**MEETING OF THE  
PLANNING AND ZONING BOARD  
QUASI-JUDICIAL PUBLIC HEARING**

**ITEM:** Request for approval for a new commercial building "Concourse Terrace II" located at 9555 Bay Harbor Terrace, Lot 13 of Block 12. On February 6, 2018 the applicant came before the Board and the plans were deferred. The applicant has attempted to address the comments. The owner is proposing to construct a new 46,692 +/- square foot commercial building. The proposed building is shown to be a 7 story in height at 65' above BFE with roof-top amenities . On the ground floor facing Bay Harbor Terrace and 95 Street there are two retail spaces that total 1,189 sq. ft.. The 2nd floor will include a private gym for the building tenants. Floors three to seven contain 17,272 sq. ft of office space. Enclosed please find the revised site plan and elevations. (Item #1)

NEW 7 STORY OFFICE BUILDING  
CONCOURSE TERRACE II

**Subject:** Site Development Plan Application  
Concourse Terrace II – Retail / Office Building  
9555 Bay Harbor Terrace  
Bay Harbor Islands Process No. SPR17-00002  
MMPA Acct. No. 01-0702-1064

1 SITE PLAN  
1" = 10'-0"

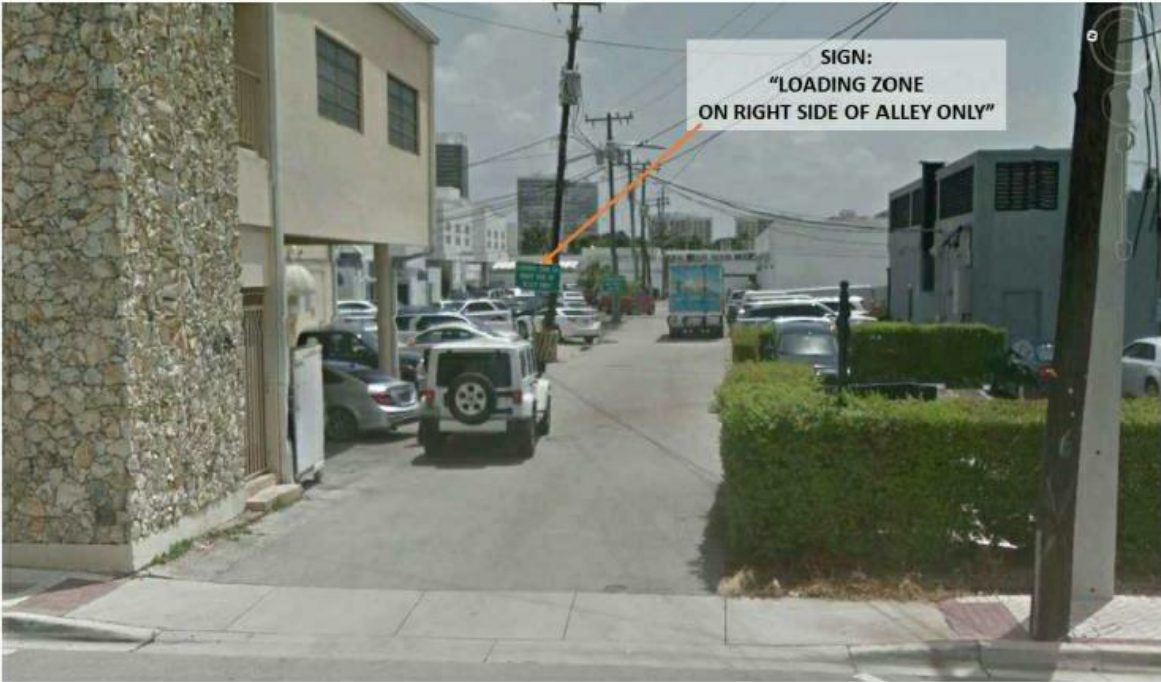
The site plan shows a single two-way vehicular driveway entrance from the 20-foot wide public alley on the north side of the building through a 24-foot wide opening with overhead roll-up door opening with 17'-3/4" of vehicle stacking provided (one vehicle). Proposed onsite are 64 parking spaces with 56 on a "rotisserie" style mechanical parking system operated by a valet service. While eight (8) parking spaces will remain on the "north site", most of the existing parking provided in the surface lot for the building to the north is apparently being eliminated by this development, due to a recent Town Code amendment designed to encourage more active Kane Concourse land uses. Despite the lower parking requirement, in total the "sites" will be short at least 44 required parking spaces; therefore, acquisition of additional parking spaces will be necessary from the Town's Parking Trust.

The current access to the surface parking lot is only from 95<sup>th</sup> Street. Bollards block access to the driveway connection to the alley. The proposed site plan depicts one 20’ wide access driveway from the alley to the parking garage, through a 24’ wide opening, with 17’-3/4” for vehicular stacking from the alley on the north side of the site.

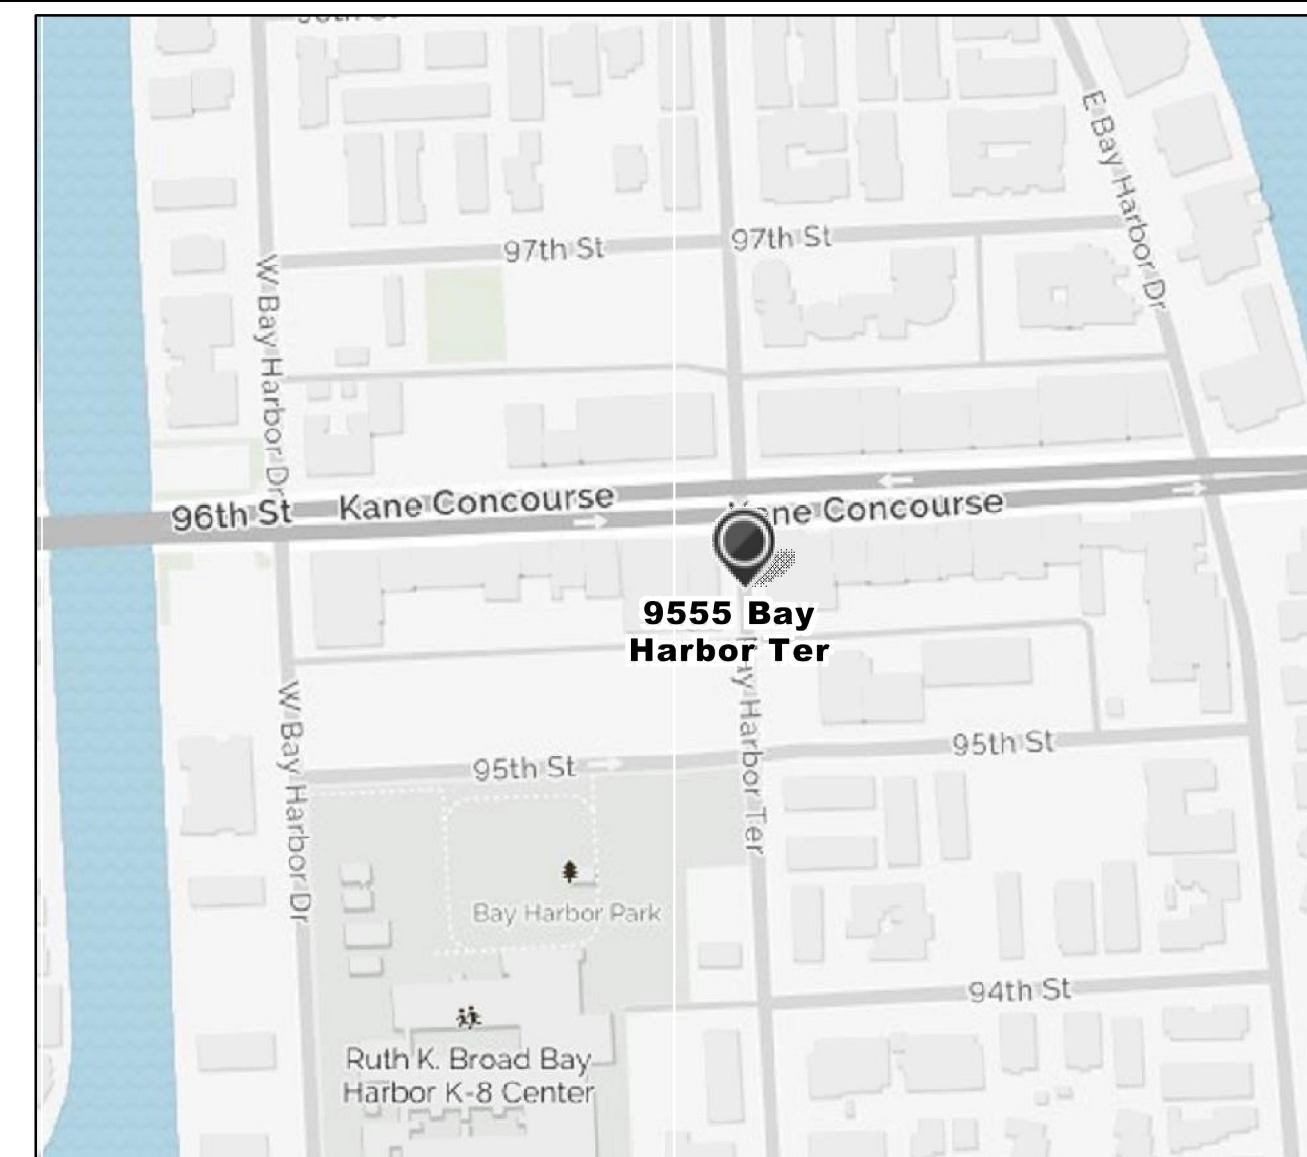
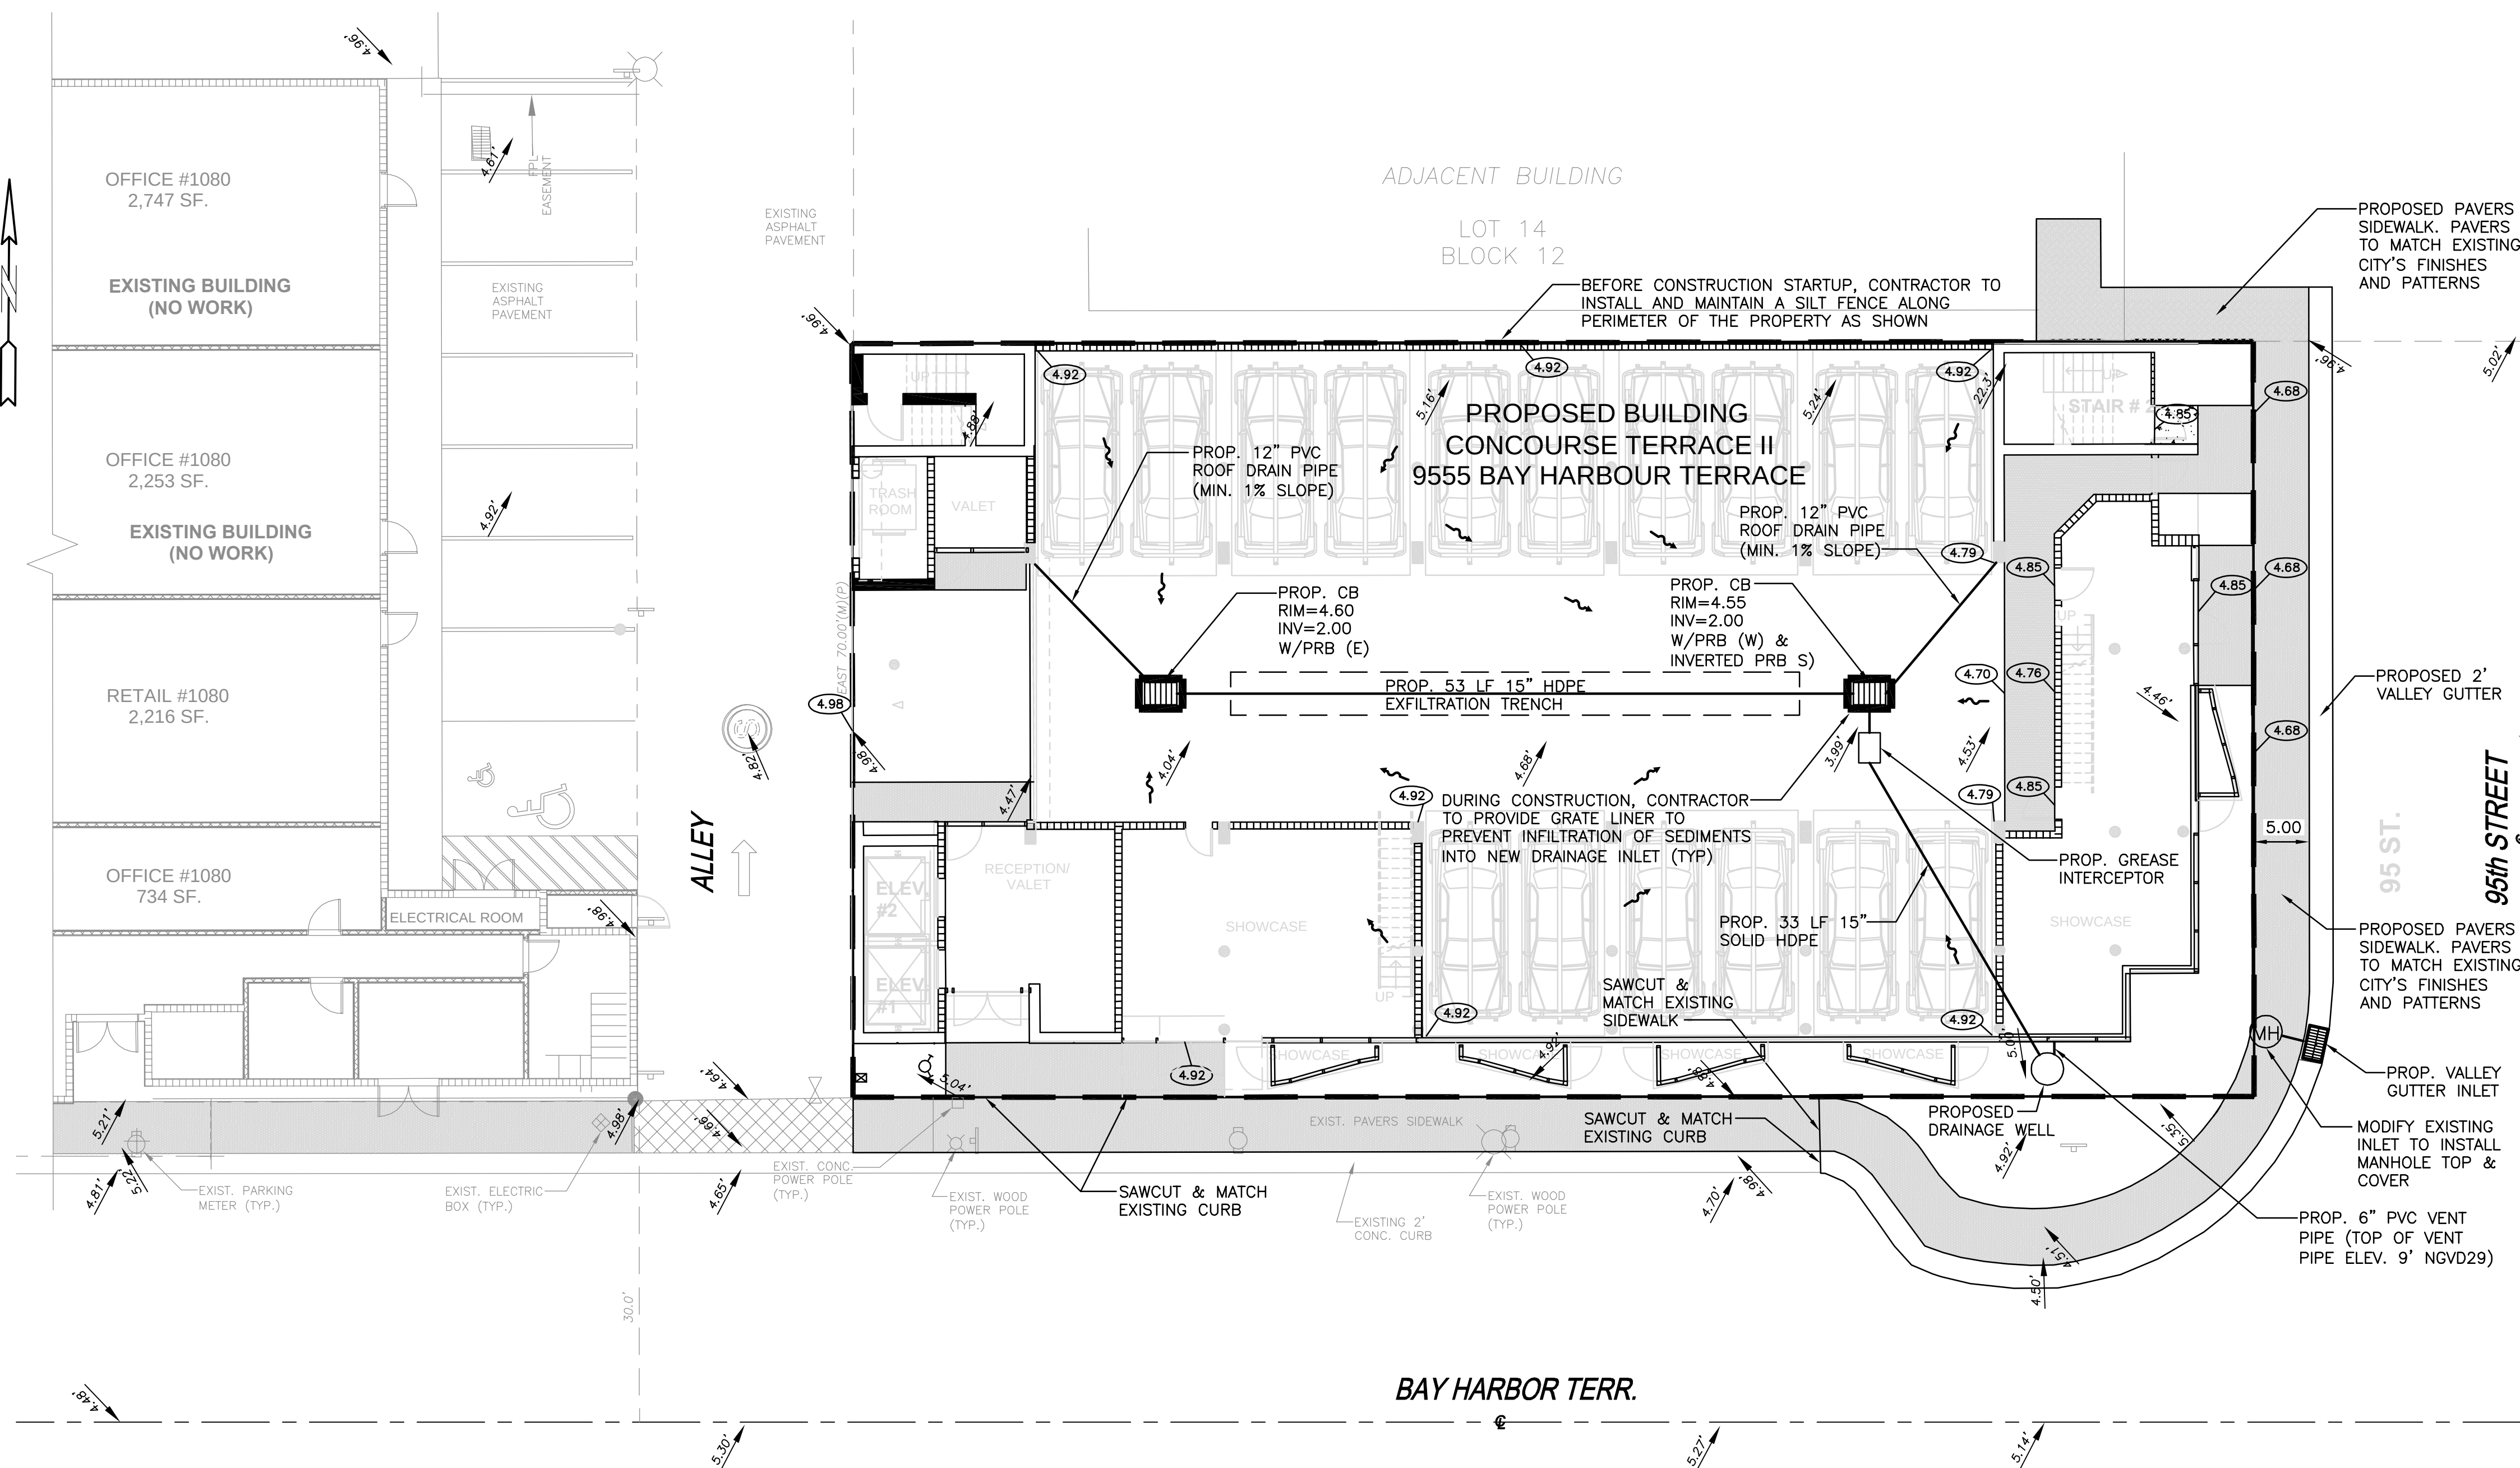
- 1) The mechanical parking system (vehicle lifts) require approval from the Planning & Zoning Board pursuant to §23-30(f) per the Town Attorney's legal opinion.

2. The mechanical parking system requires specific approval from the Planning & Zoning Board pursuant to §23-30(f) and Town Attorney legal opinion (assigned previous TC approval to PZB). This will obviate the need to comply with the construction and dimensional requirements (paving, layout, markings, car stops) listed in §19-23 and §23-30 that the parking lift system could not comply with.
